CONSTRUCTION PLANS

ADVENTHEALTH PARKER EXPANSION

DRAWING TITLE: **COVER SHEET**

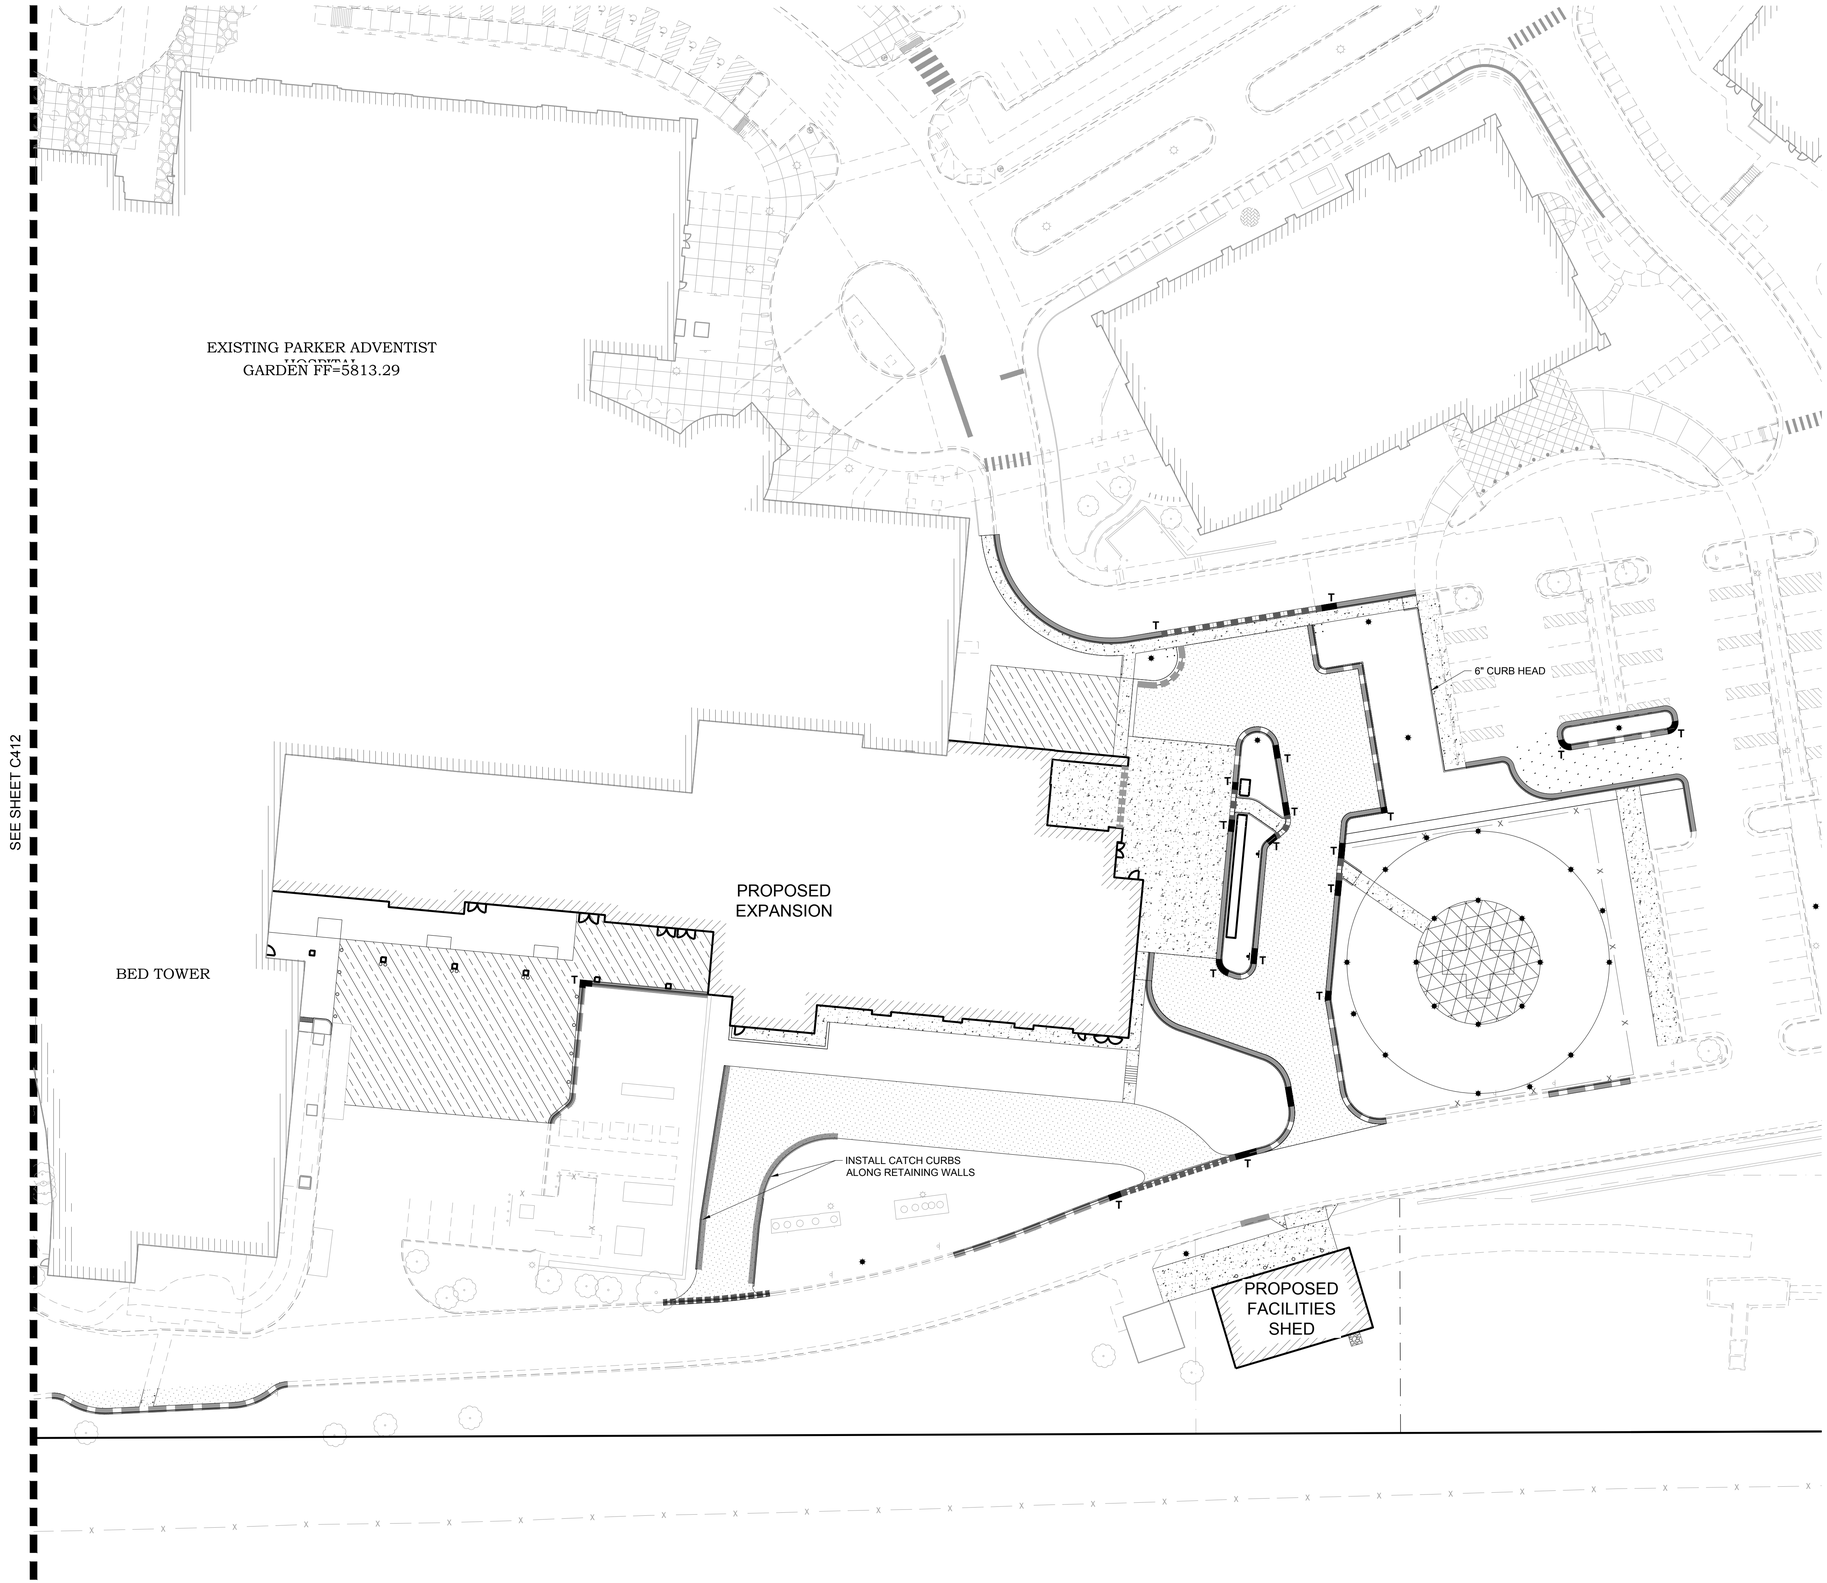
Please include Key Map

C501

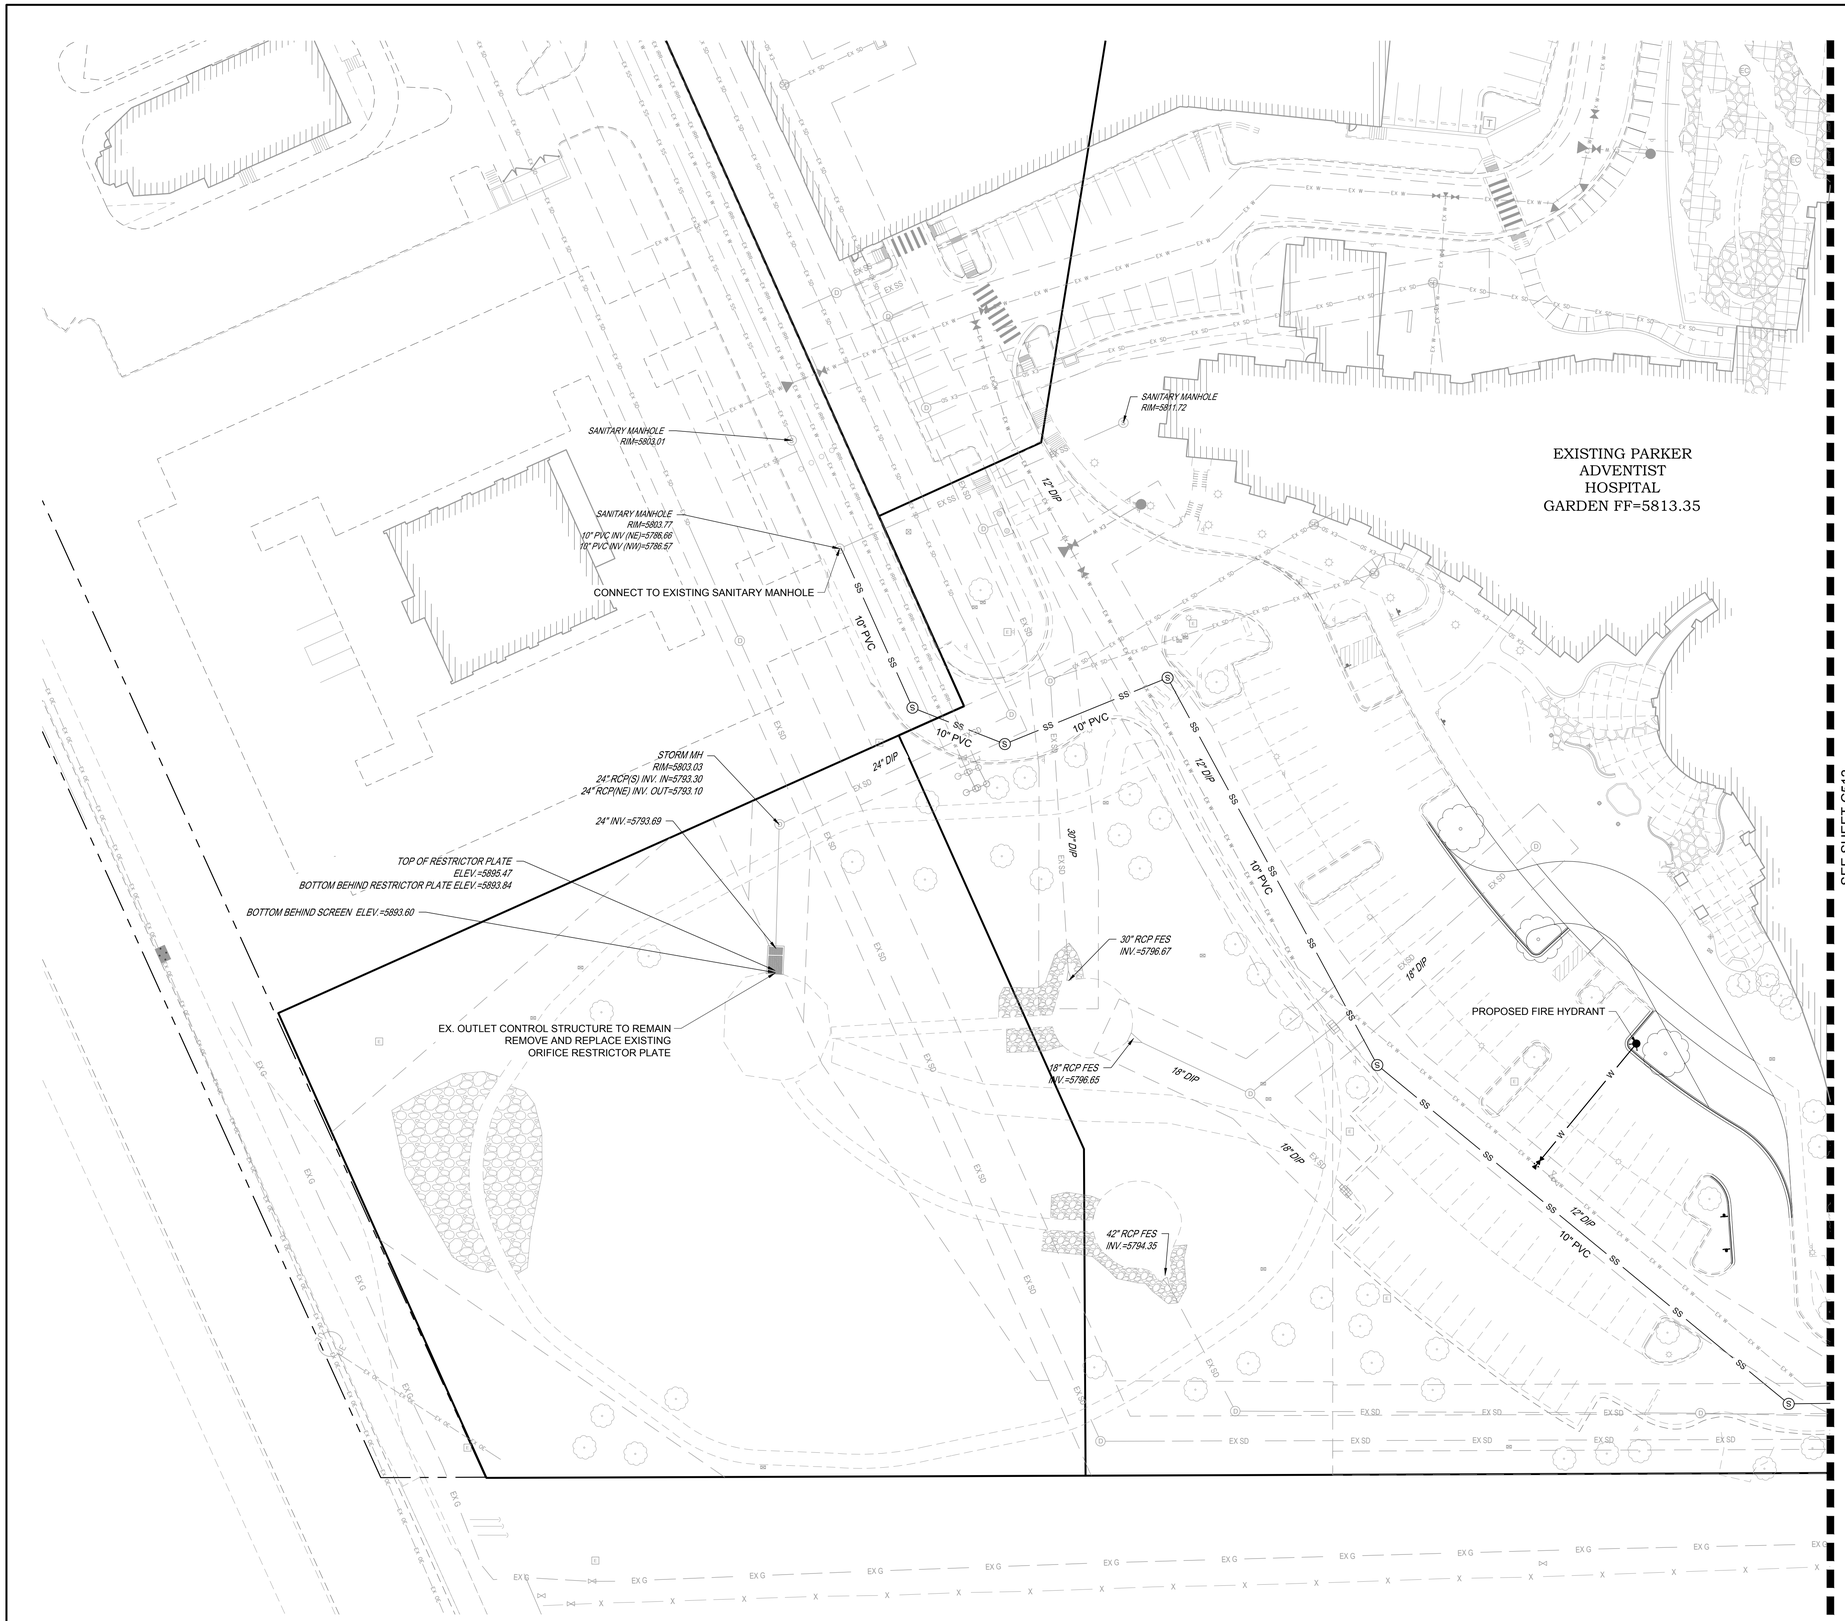
Please include Key Map

C511

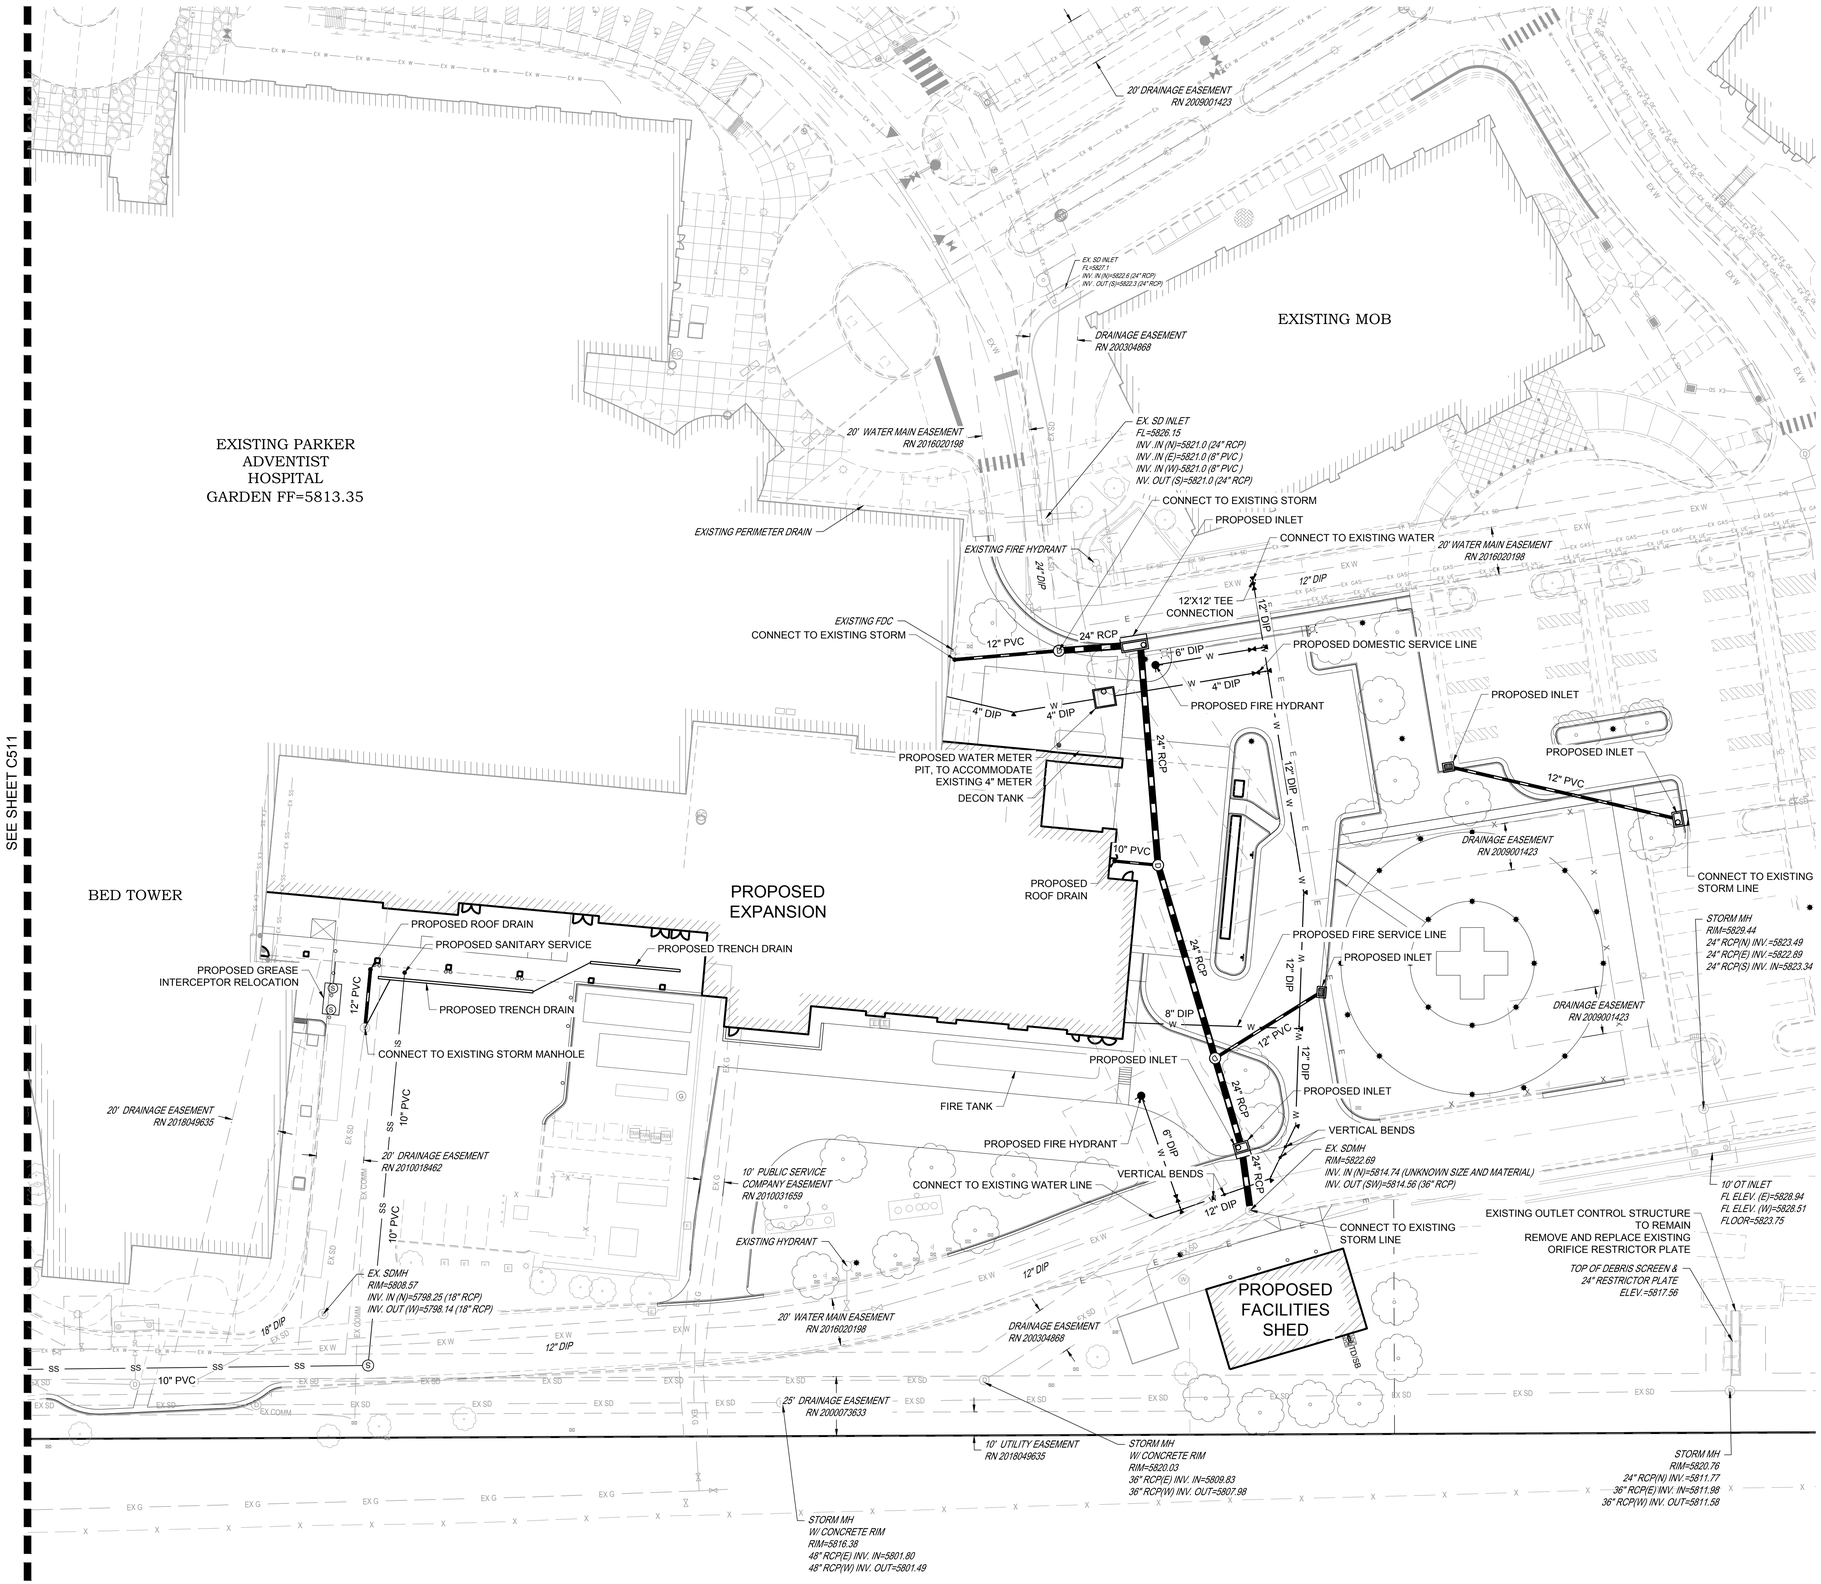
Please include Key Map
